ALEXANDER BOULEVARD ROADWAY IMPROVEMENTS GRIEGOS ROAD TO CARMONY LANE

RECORD DRAWING MARCH 87

CITY OF ALBUQUERQUE
PUBLIC WORKS DEPARTMENT
ENGINEERING DESIGN (TRANSPORTATION)
TITLE: ALEXANDER BOULEVARD
GENERAL NOTES, TYPICAL SECTION
AND MISCELLANEOUS DETAILS

BLOCK MASONRY RETAINING WALL DETAILS

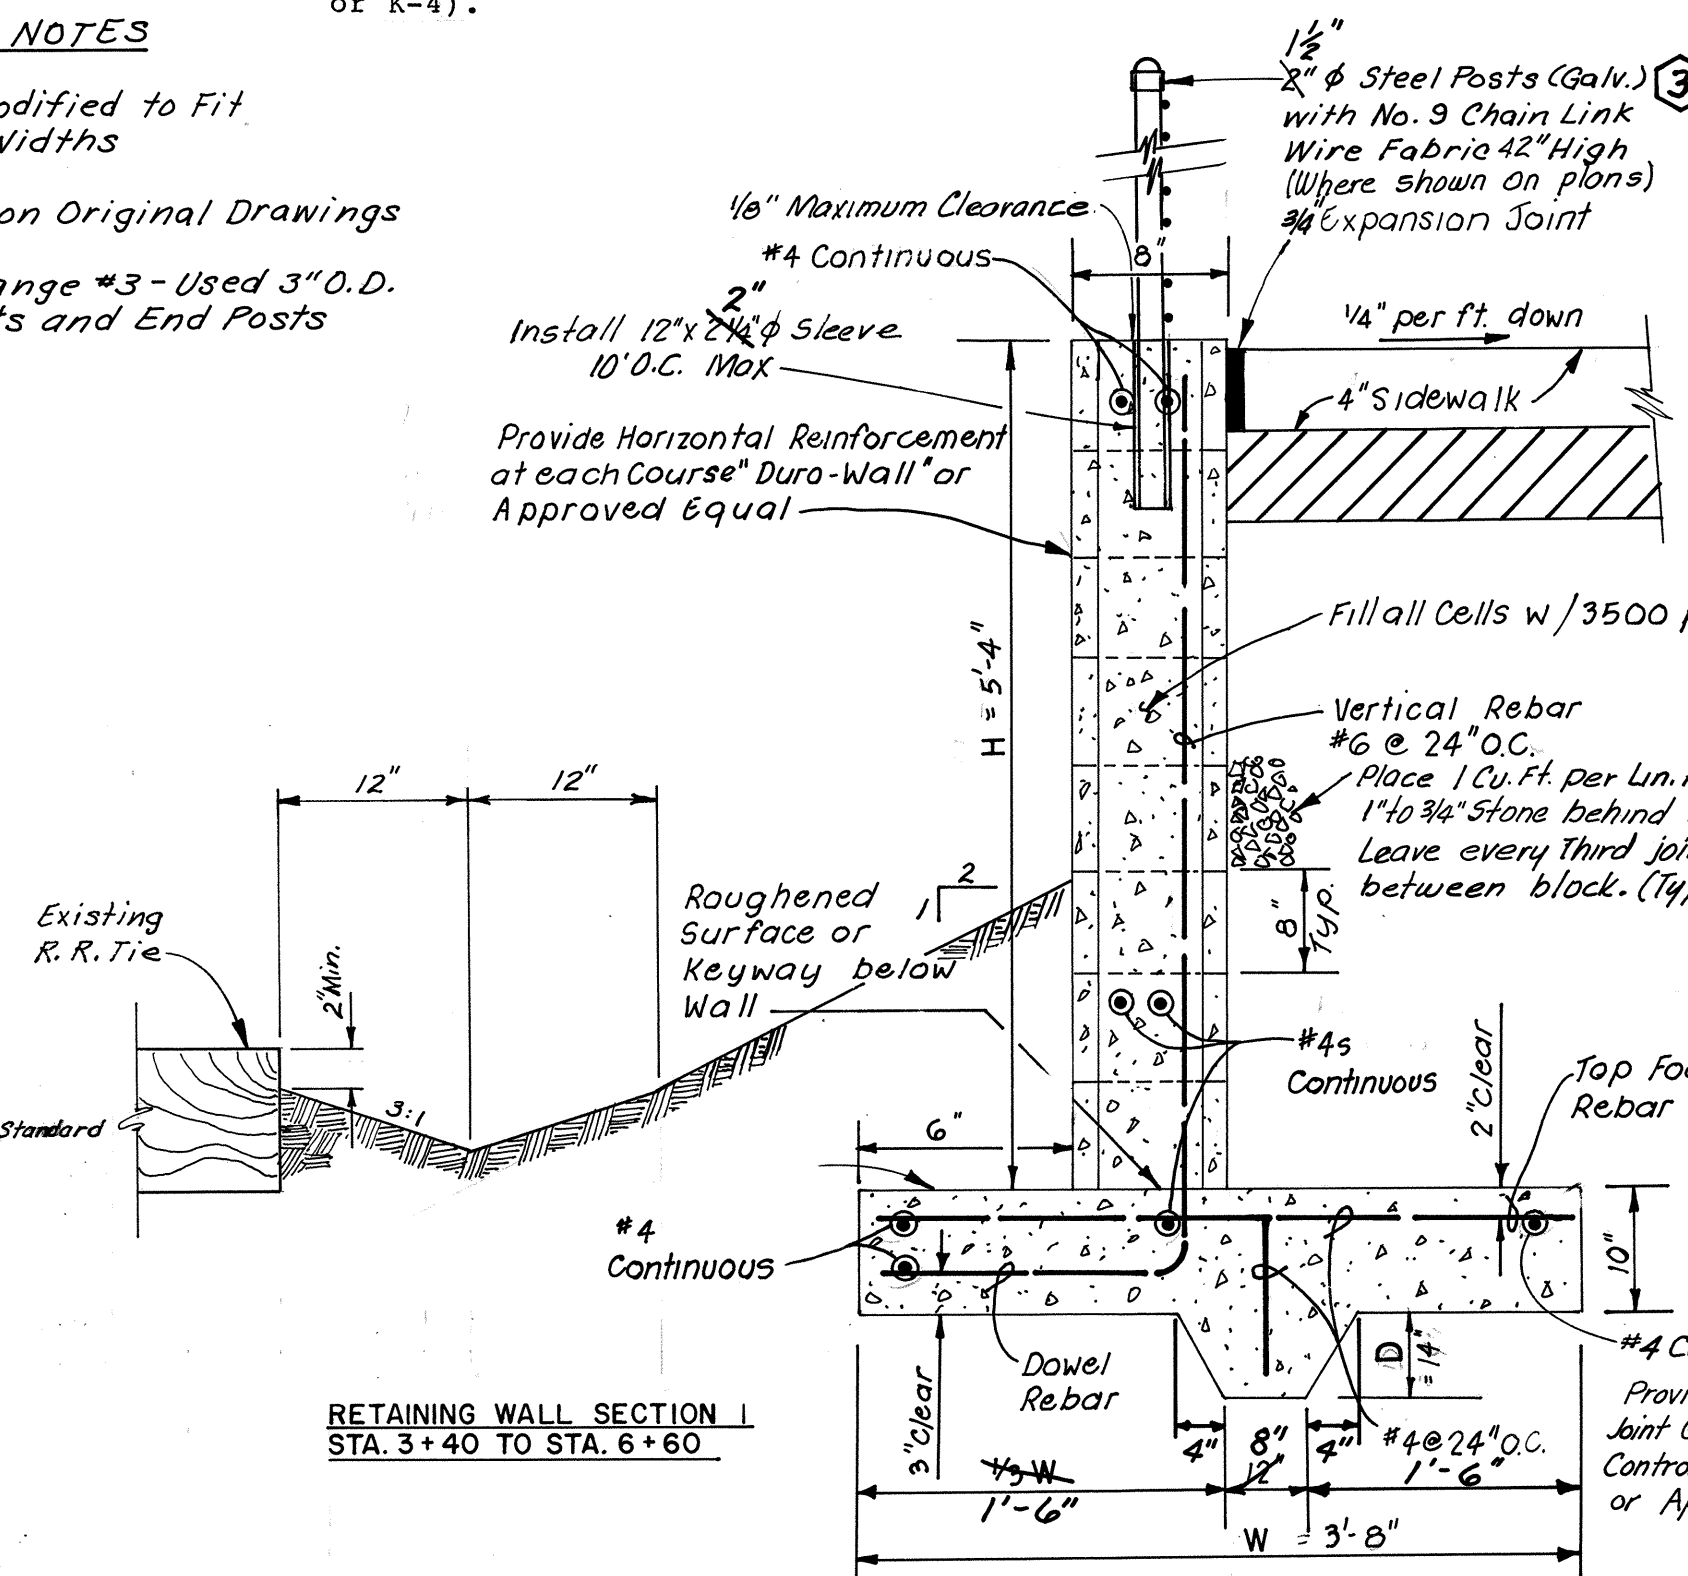
- Keyway Modified to Fit Footing Widths
- Omitted on Original Drawings
- Field Change #3 - Used 3" O.D. Full Posts and End Posts

TITLE: PAVING PLAN & PROFILE
ALEXANDER BOULEVARD
STATION 1+00 TO STATION 3+50

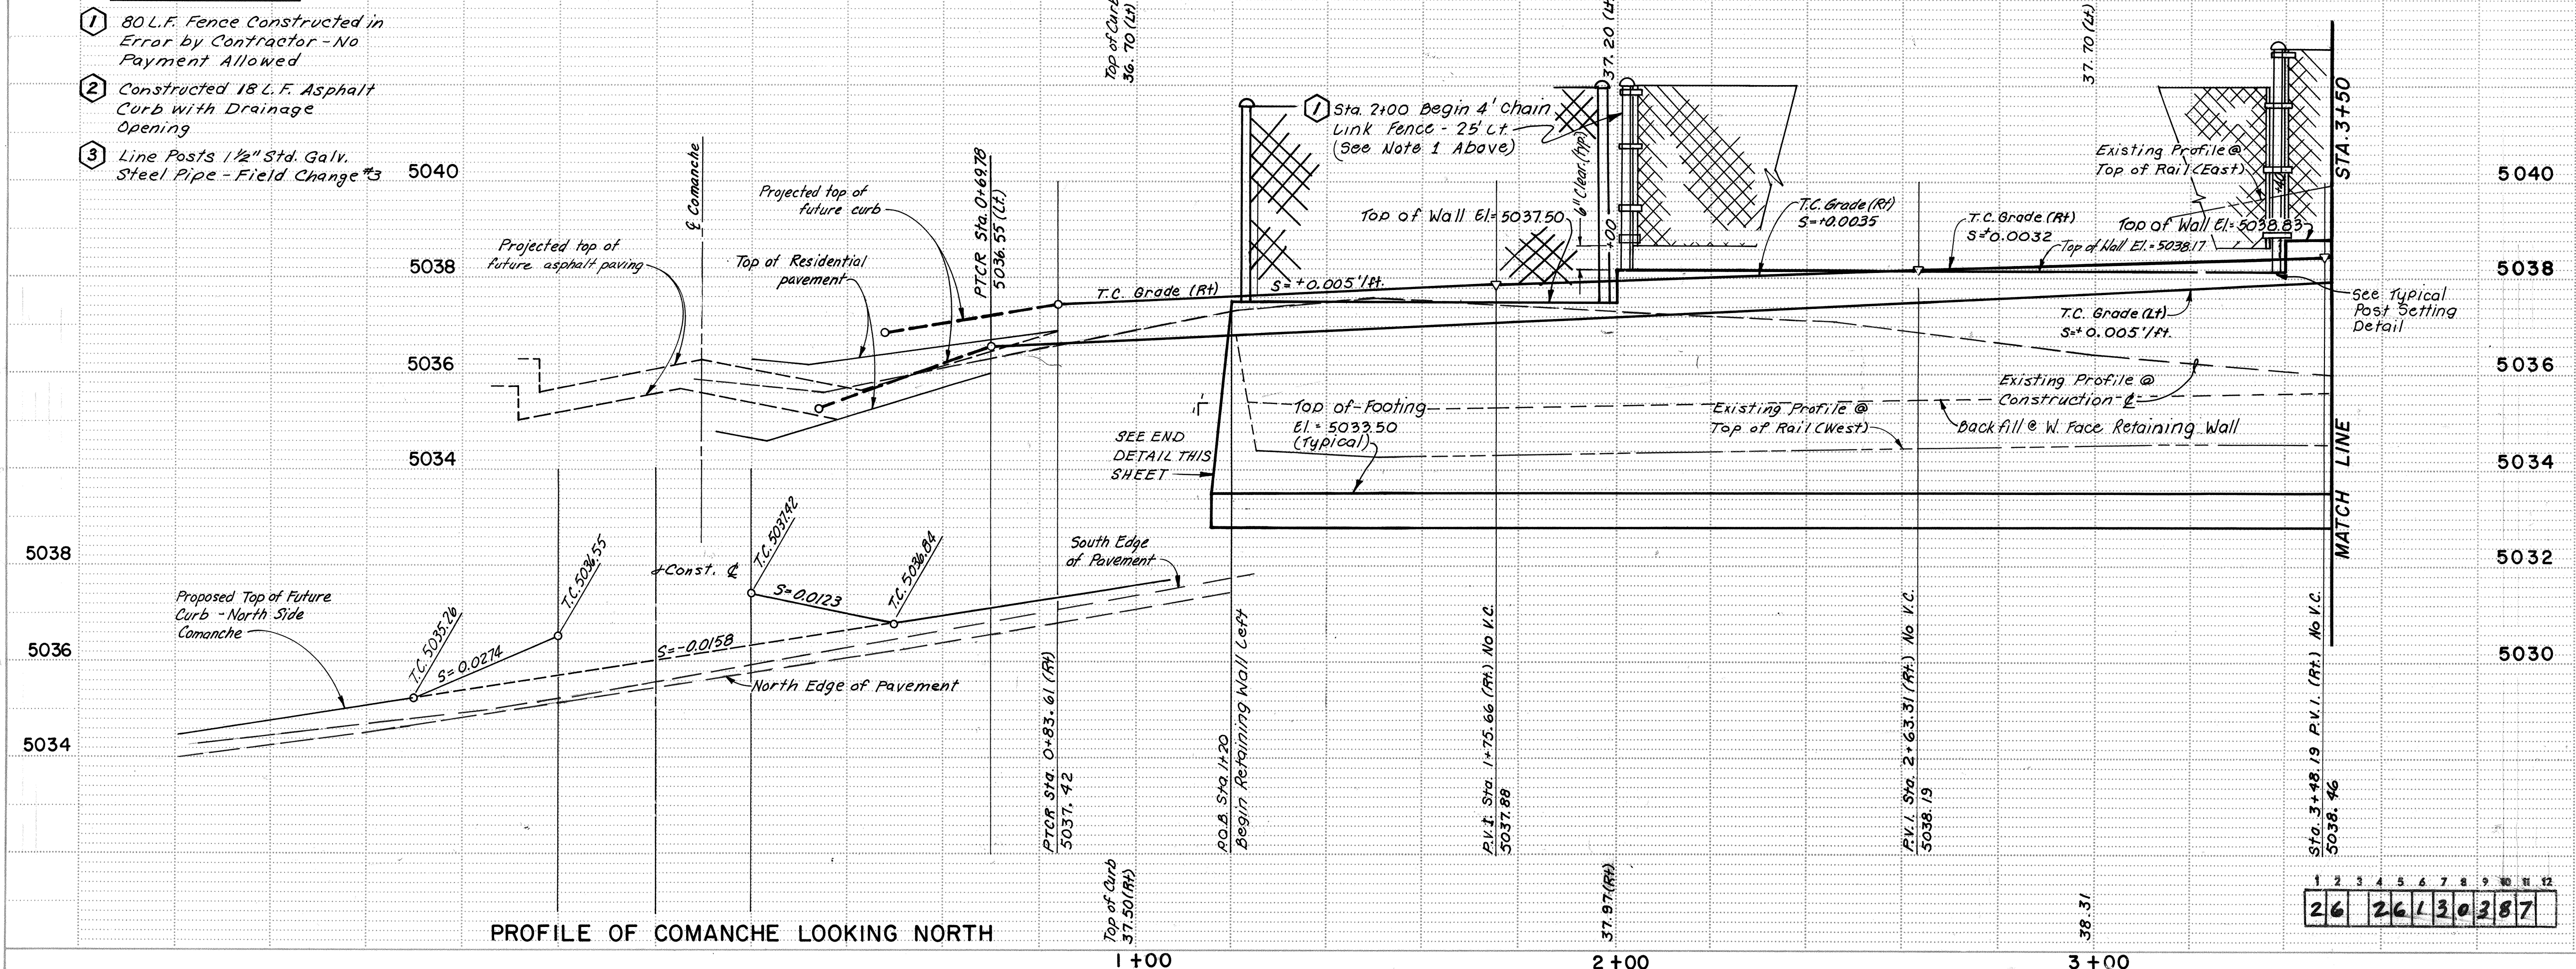
- 80 L.F. Fence Constructed in Error by Contractor - No Payment Allowed
- Constructed 18 L.F. Asphalt Curb with Drainage Opening
- Line Posts 1/2" Std. Galv. Steel Pipe - Field Change

TITLE:
PAVING PLAN & PROFILE
ALEXANDER BOULEVARD
STATION 3+50 TO STATION 8+00

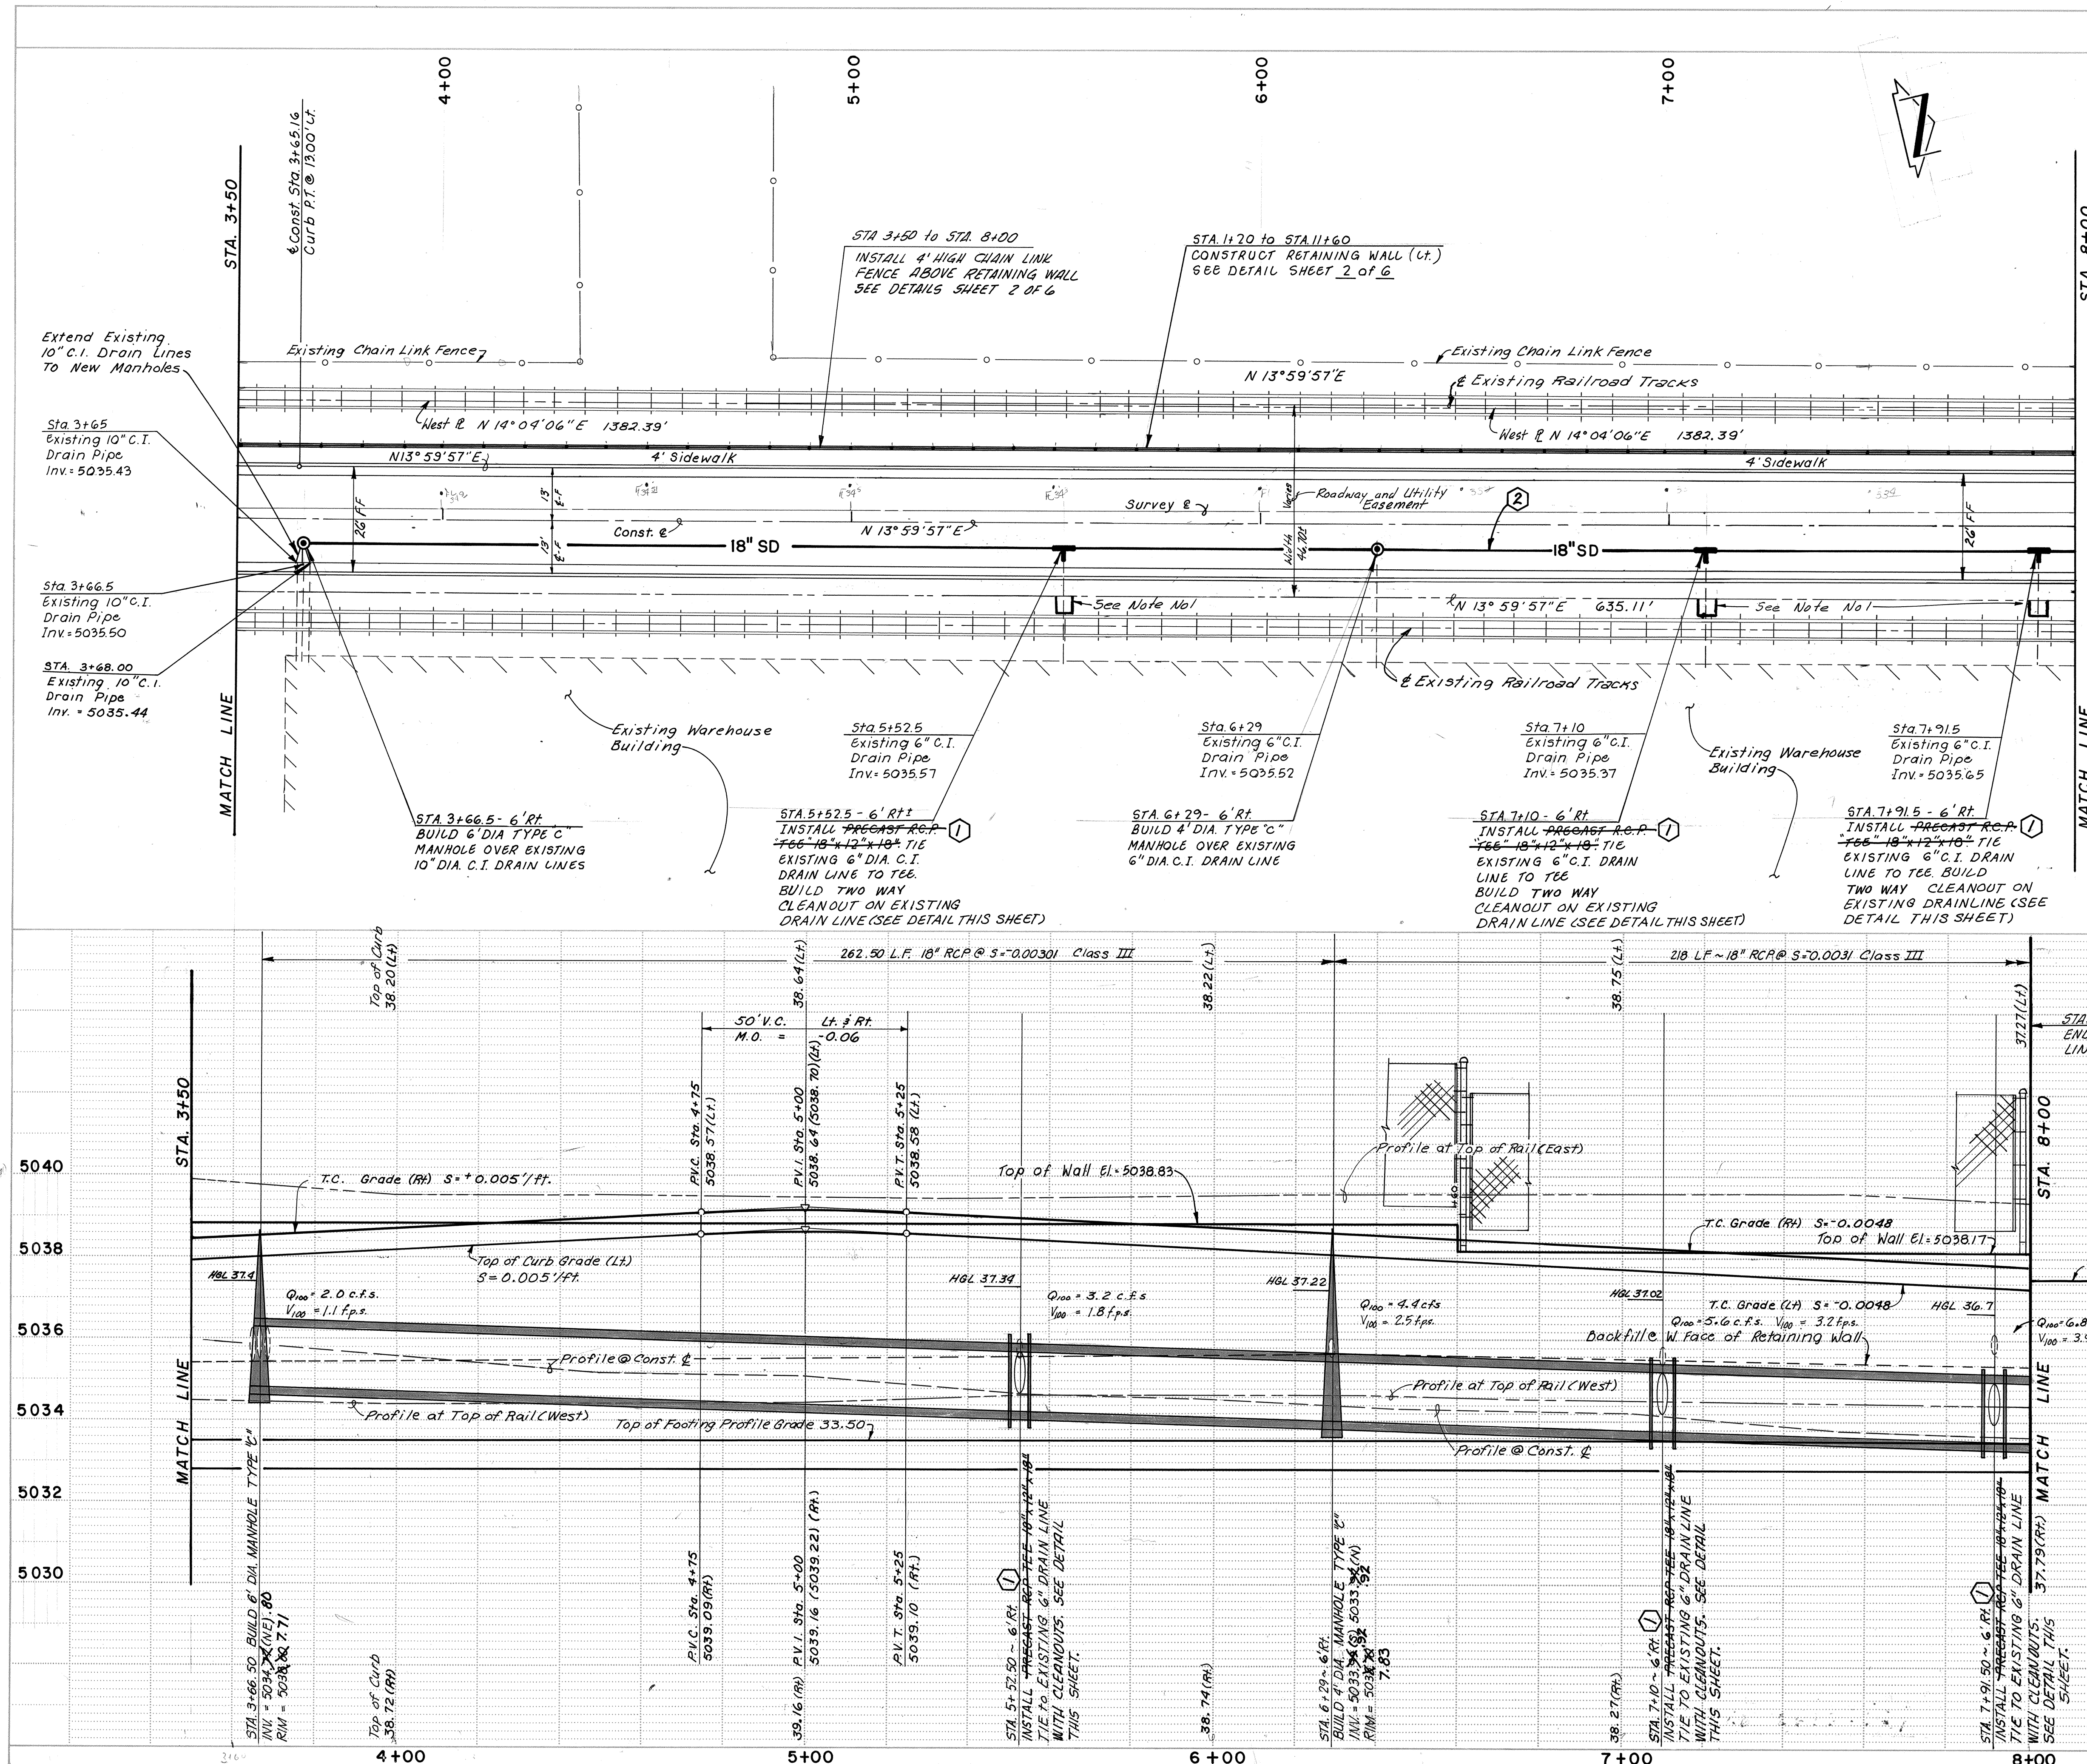
- 18" x 6" Tapping Saddle - Field Change #4
- 18" Storm Drain Line Relocated Per Revision No. 1 This Sheet As Shown - Field Change #2
- Installed 18" x 6" Stainless Steel Strap Tapping Saddles With 6" Drilled Holes in 18" R.C.P. No Change in Contract Price - Field Change #4
- Substituted Standard 6" x 4" C.I. Double Cleanout Fitting, in Lieu of Detail as Shown on Original Drawings - Field Change #2
